ADDENDUM

DATE: December 9, 2011
FROM: Spectrum Engineering
TO: All plan holders of record
PROJECT: TOOT'N TOTUM AT I-40 AND GEORGIA.

Toot 'N Totum

I-40 & Georgia Amarillo, Texas

SK1

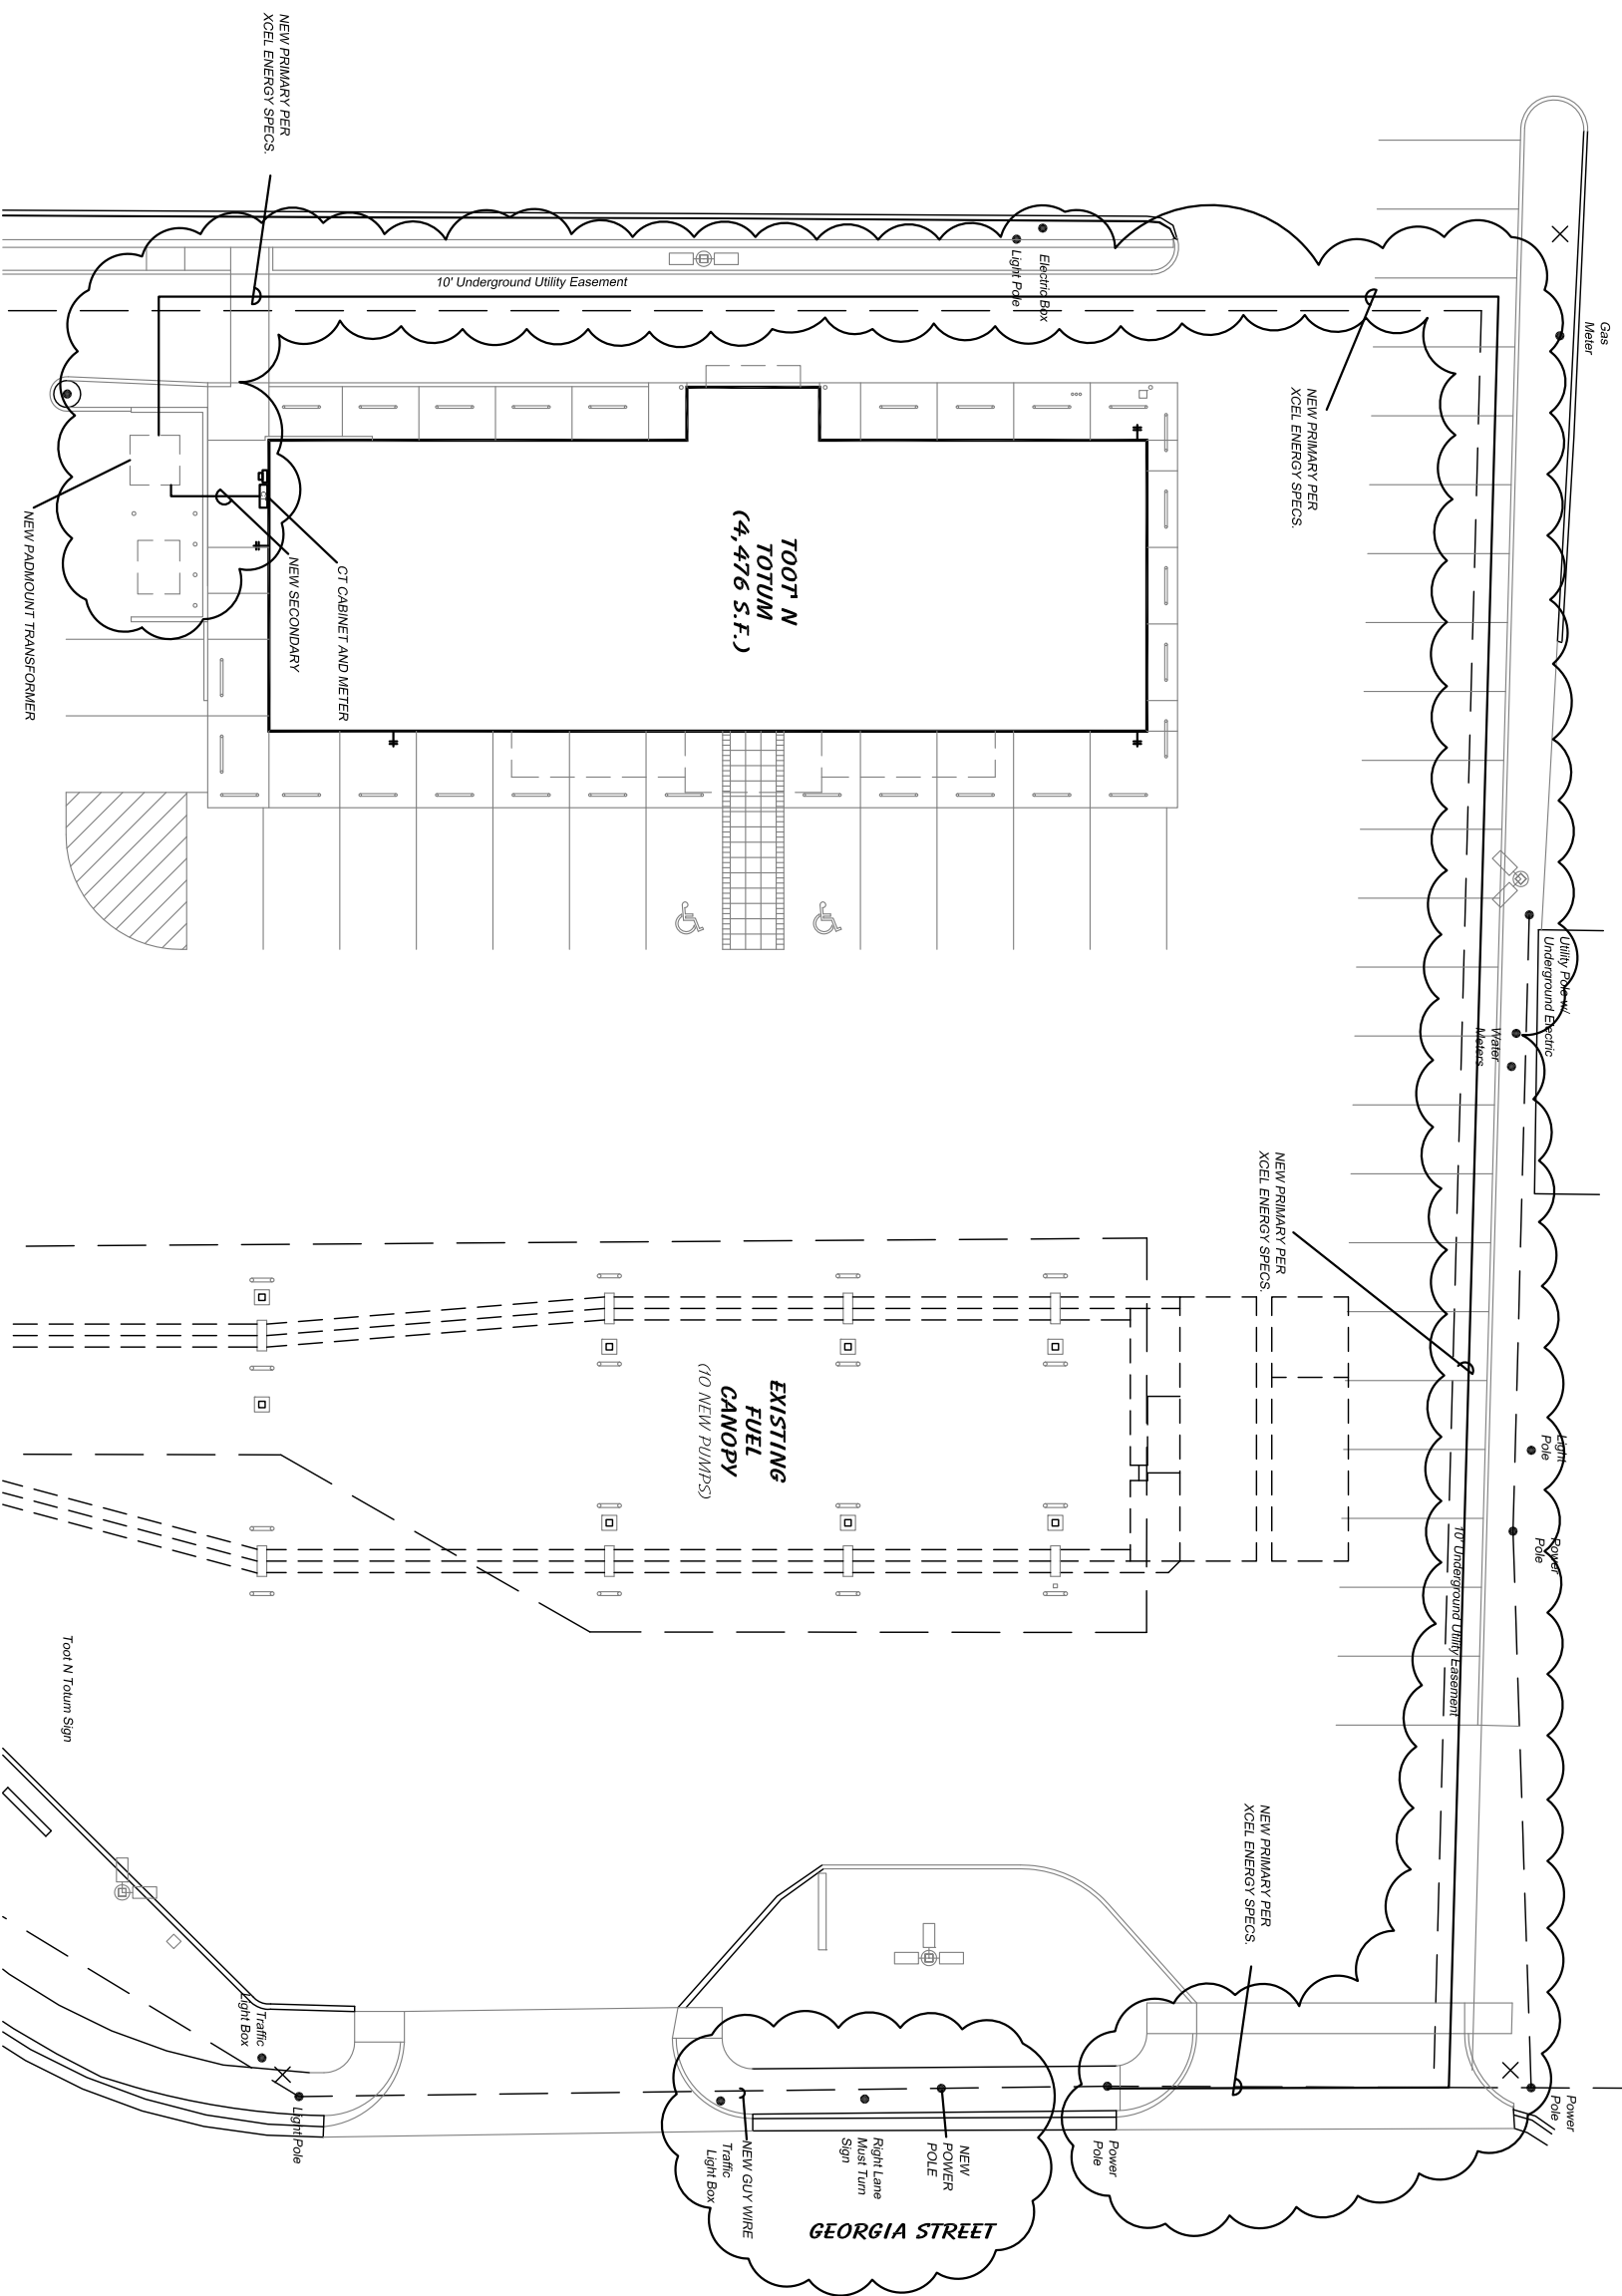
1.01 – ELECTRICAL SERVICE REVISION

The electrical service to the building shall be from a new padmount transformer located as shown on Sheet SK1. The CT cabinet and meter shall be relocated to the south side of the building as shown in Sheet SK1. A new power pole shall be added on the East side of property to extend the primary. The contractor shall ditch from the pole shown to the new padmount transformer location. All ditching shall be per Xcel Energy standards. The contractor shall provide pad for transformers and protection bollards as required by Xcel Energy. All associated fees and required equipment for this new service shall be supplied by the contractor. Contact James Savage at Xcel Energy for details on fees, required equipment, and scheduling.
